CONWAY HISTORIC DISTRICT COMMISSION MEETING

**OLD CONWAY DESIGN OVERLAY
CERTIFICATE OF APPROPRIATENESS REVIEW**

Address. 340 Conway Boulevard

PRELIMINARY STREET VIEW
330 CONWAY BLVD.

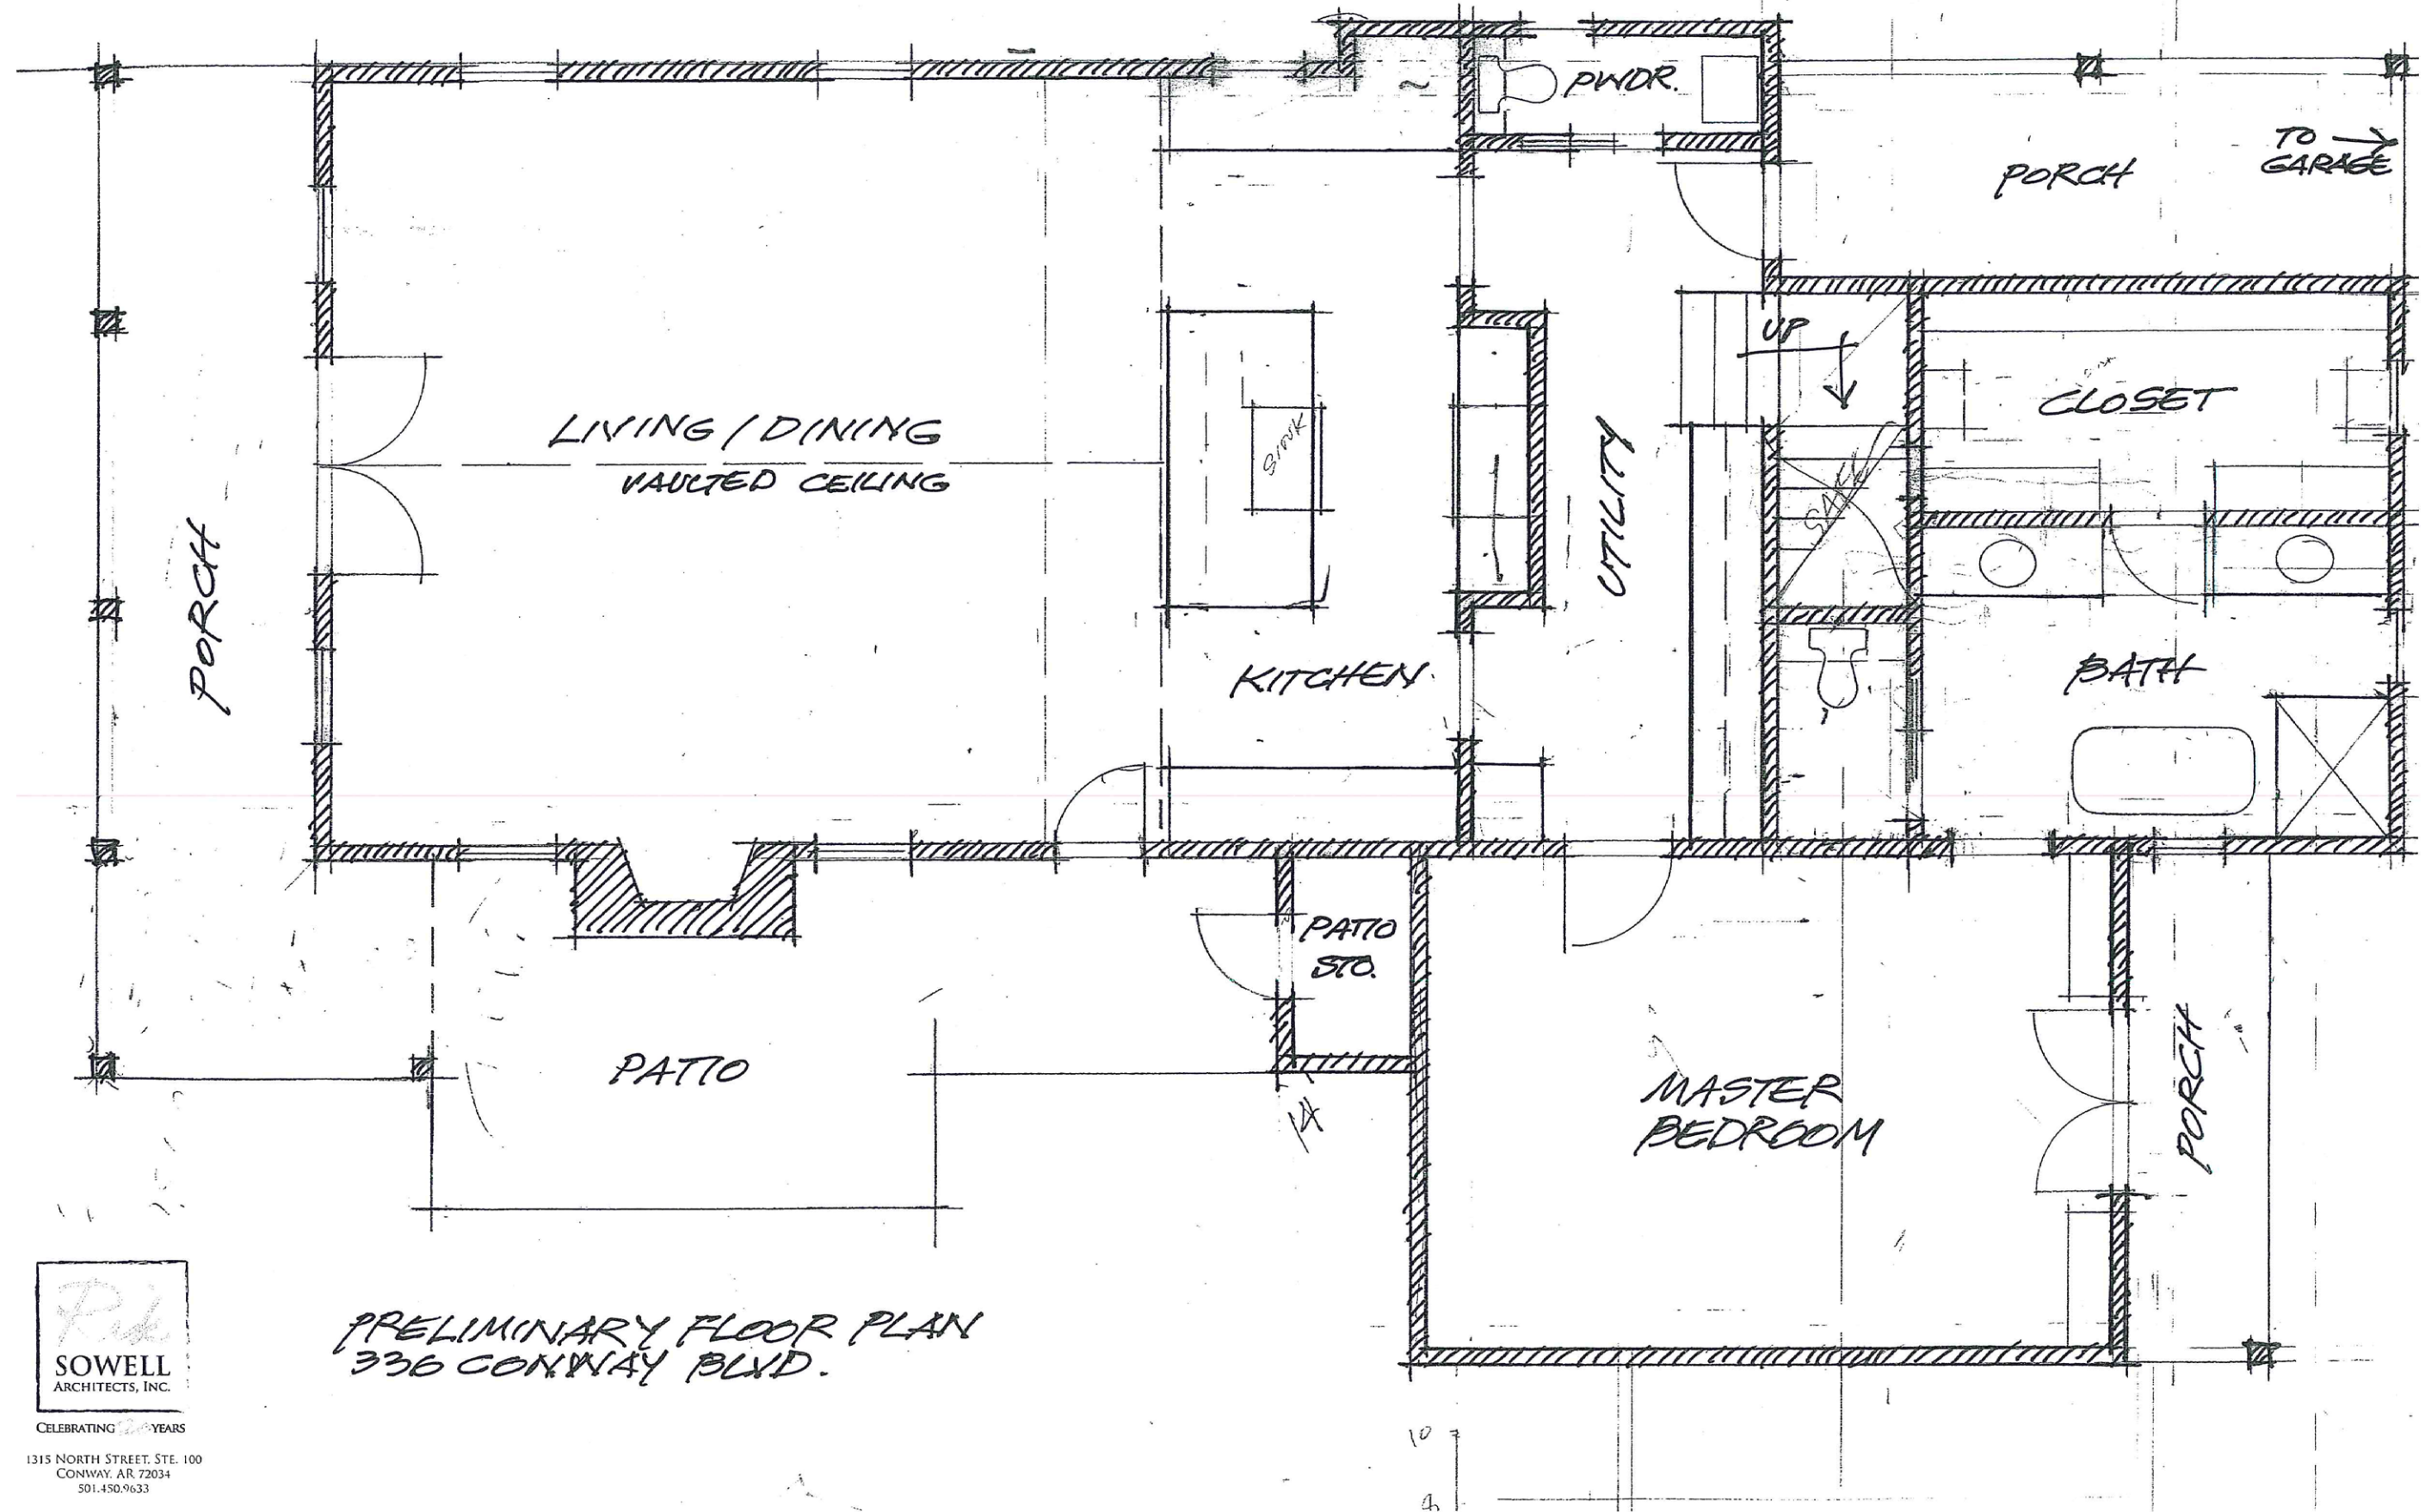
Façade, wall area, rhythm. Facades shall be compatible with surrounding historic structures in proportion of wall to opening area. The residence seems to have an appropriate number of windows and doors providing historically appropriate opening to solid area. The one area possibly lacking in openings is the master bedroom. Another window or two should be considered for this room.

Entries, Porches, and Porticos. Appropriate entry points are provided. Porches are to be a minimum of 6 feet in depth. The front porch shown is 6 feet in depth. The columns as shown appear to be too narrow. The column width should be increased to have a solid appearance.

Architectural Details, Siding, and Bricks. Eaves, brackets, dentils, cornices, molding, columns, trim, etc. The residence as shown, has minimal details accomplished through brick coursing, contrasting roof materials, painted brick, etc. These details would seem to be appropriate with area residences. The overall siding materials and scheme is unclear based on the supplied drawings. It would appear to be brick, however, the applicant can provide details at the meeting.

1. The residence shall be constructed as shown in submitted plans.
2. Driveway shall be concrete.
3. The residence's front setback shall be approximately 45 feet. Side setbacks shall be approximately 10 feet on the south and 25 feet on the north. Outbuilding north setback shall be approximately 5 feet from the north. All setbacks are measured from the structure to the property line.
4. Porch columns shall be a minimum of 8 inches by 8 inches.
5. The two significant trees along Conway Boulevard shall be preserved.
6. Additional windows shall be required in the Master bedroom?
7. Residence and outbuilding siding materials shall be brick?
8. HVAC and utility equipment shall be appropriately located at the rear or side of the structure and/or appropriately screened.

PRELIMINARY SITE PLAN
330 CONWAY BLVD.

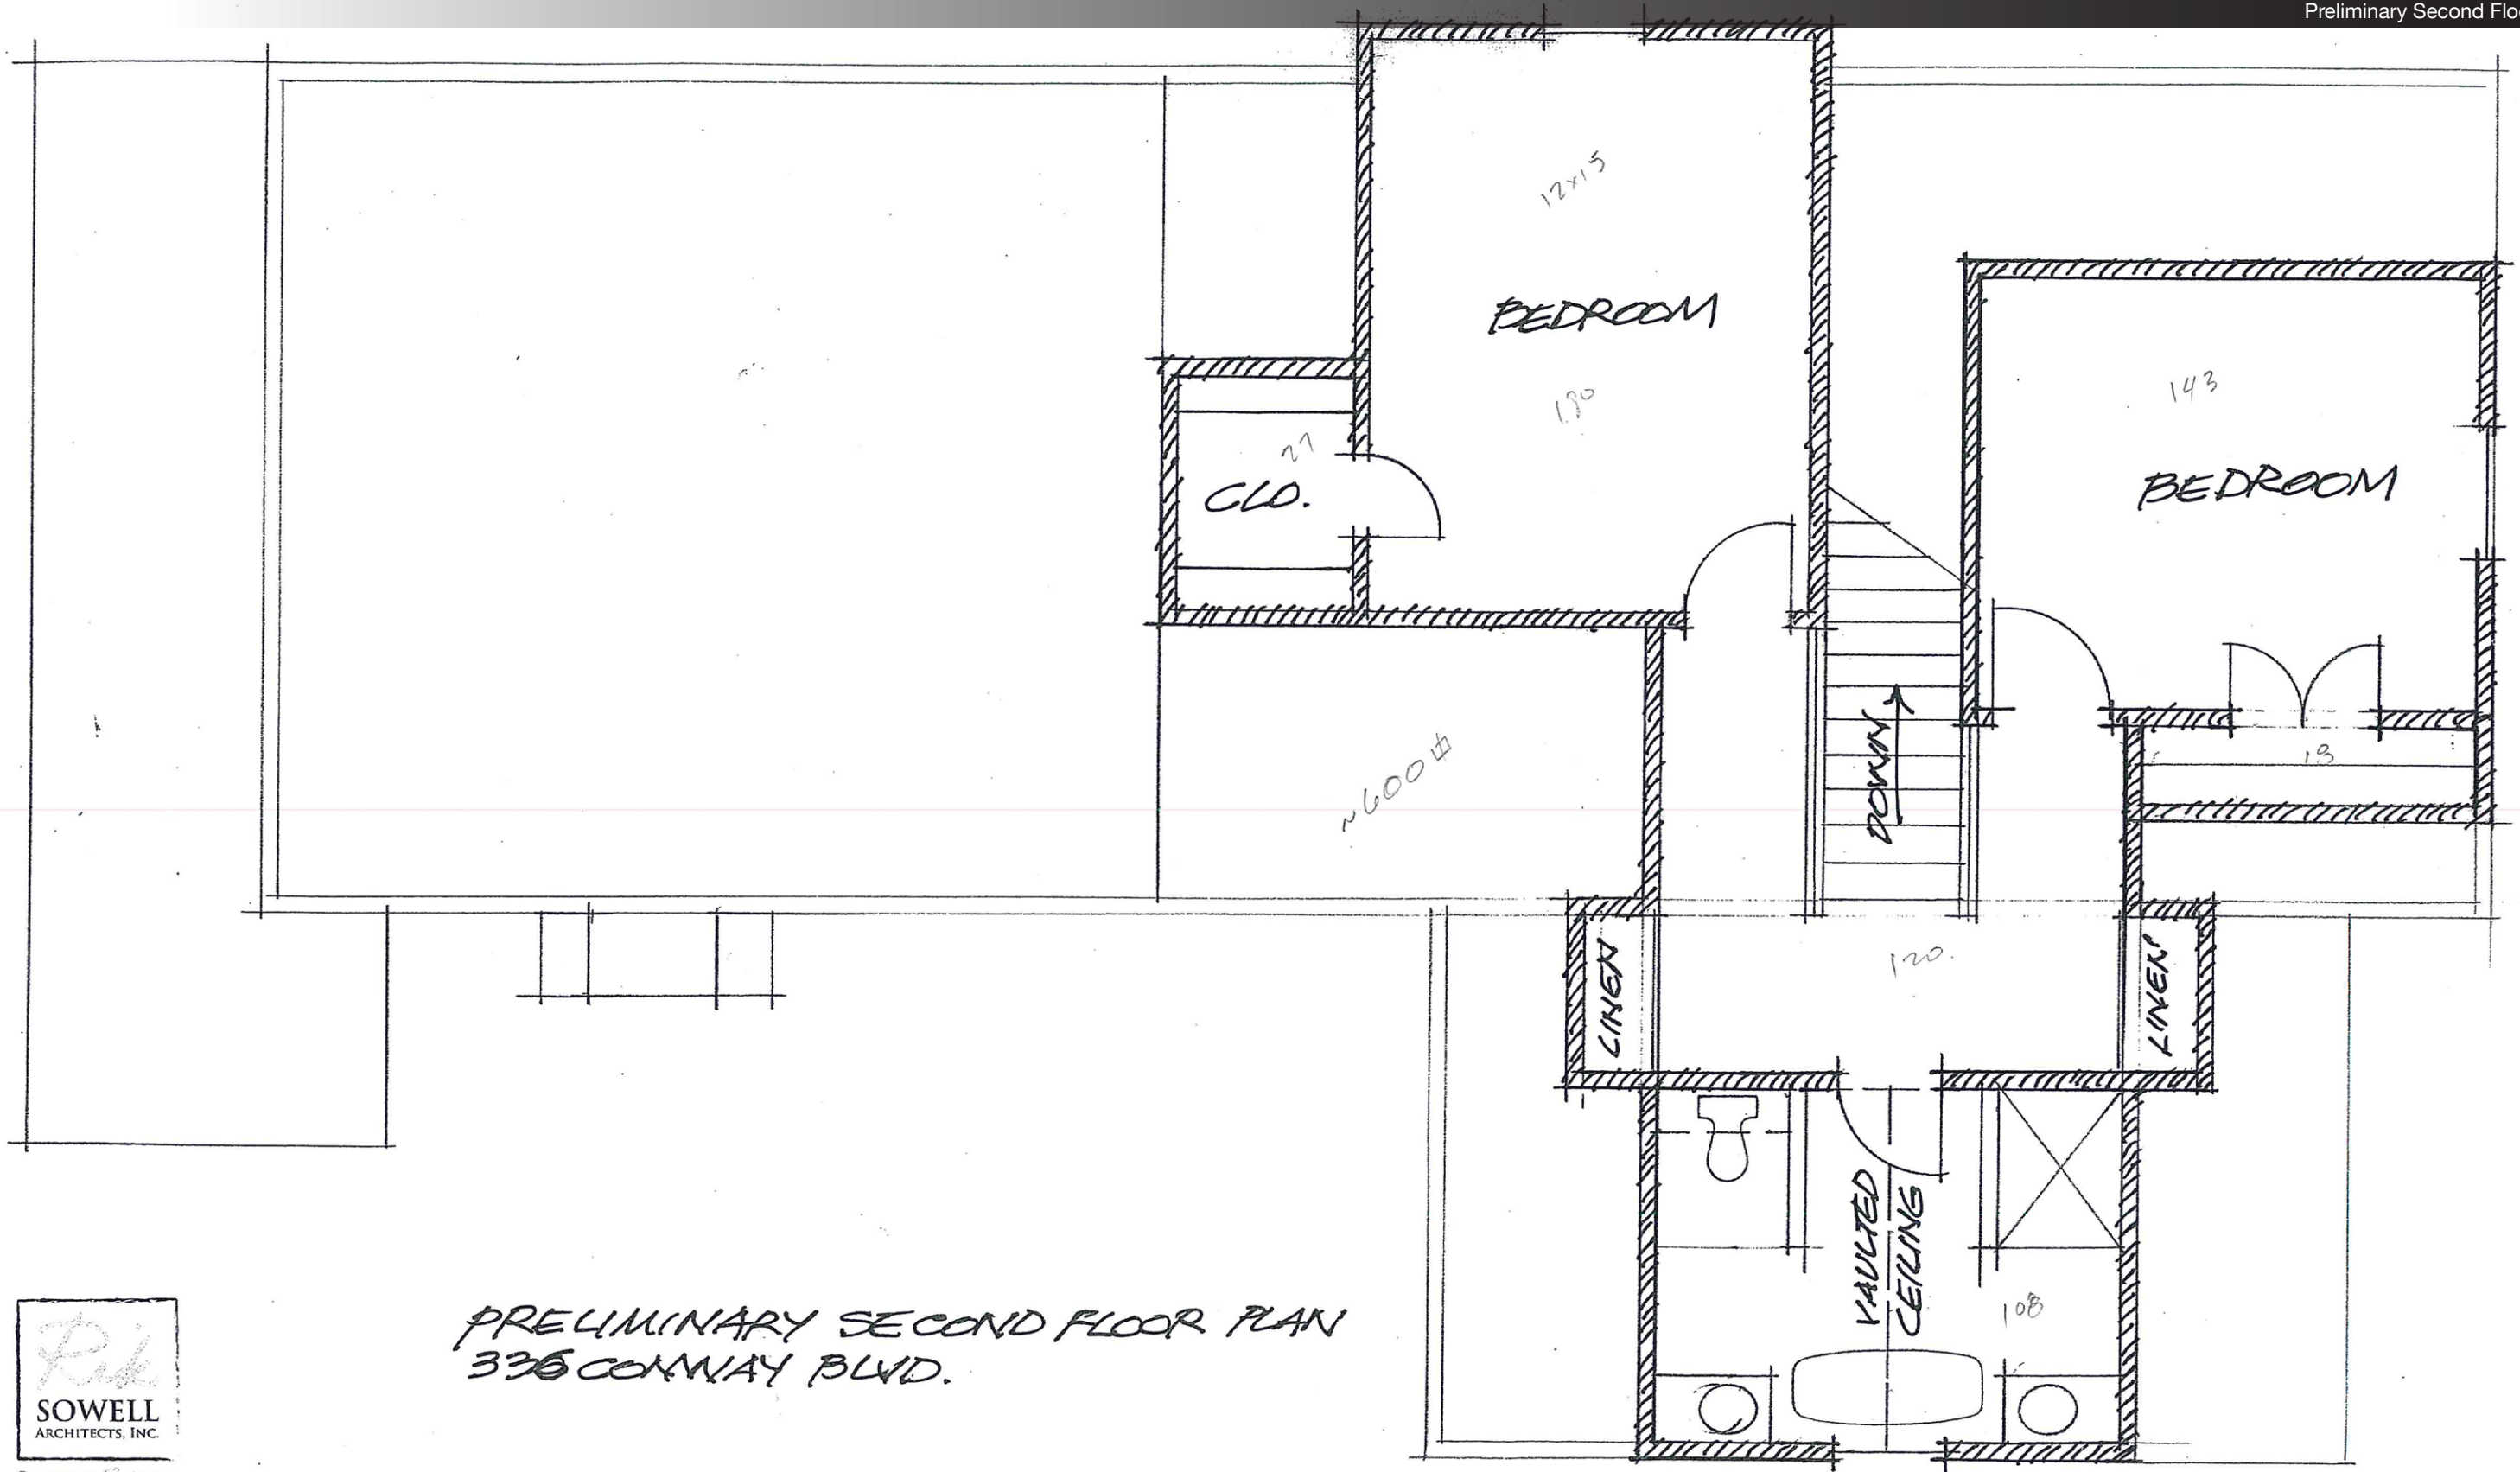
Setbacks. Proposed setbacks should respect the predominant setbacks of area structures, especially the front setback. Front setbacks are allowed within a range of 80% to 110% of the average area front setback. For this area, the acceptable range is 33 to 45 feet. The proposed front setback of 45 feet is appropriate. Side setbacks are appropriately set at 25 feet on the north and 10 feet on the south. The outbuilding has an appropriate 5 foot setback on the north and is well away from the rear of the lot.

Spacing. Established spacing distance pattern between area structures. The proposed spacing is appropriate and in keeping with other area structures. The outbuilding will need to be 10 feet from the residence in order to meet fire code.

Driveway / Parking. A driveway is proposed in the approximate center of the lot. It is assumed that the driveway will be concrete. The drive will have a front yard turn around area and travel along the north side of the house to the detached garage/outbuilding. No more than 50% of the front yard may be paved for parking. The proposed driveway is appropriate.

Tree preservation. There are 2 significant trees at the front of the lot along Conway Blvd. These are shown as preserved in the submitted site plan. The driveway is spaced well enough away from these trees to not impair them.

Current Exterior of the Residence

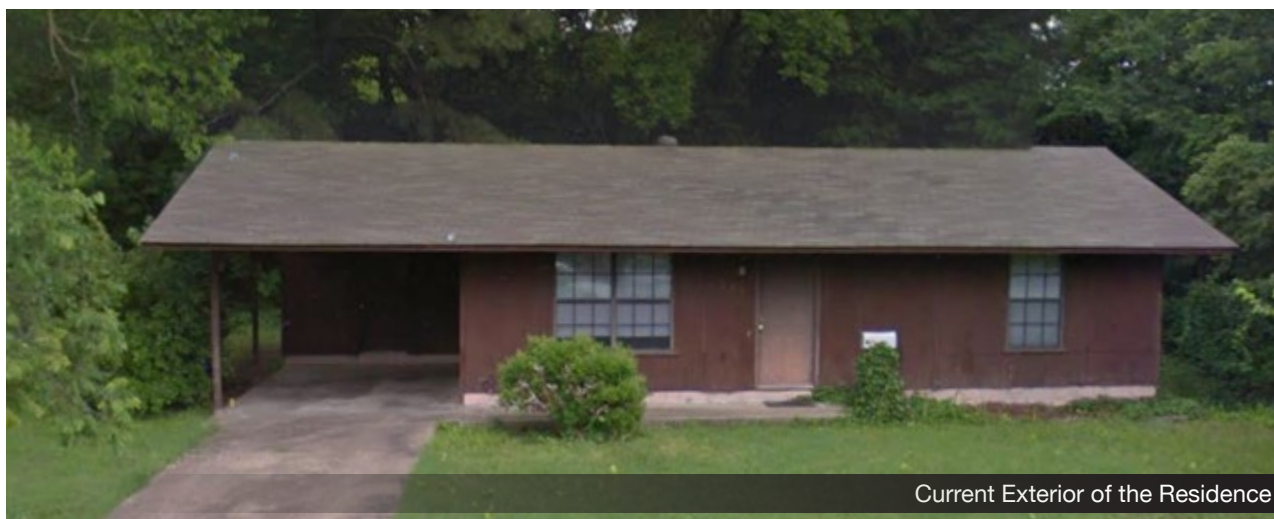
General Description of Property. The residence is clad with plywood siding and board battens. The applicant would like to either repaint or replace the plywood siding with vinyl siding. Paint and color does not require HDC approval, however a change of siding material will require an approved HDC Certificate of Appropriateness. The house is a non-contributing structure. Although vinyl siding is seen as a non-historic material, the current plywood sheathing is also non-historic. Vinyl siding could be seen as an "upgrade".

Since the residence is a non-contributing structure with non-historic plywood siding and battens, Staff recommends allowing the residence to be covered with vinyl siding.
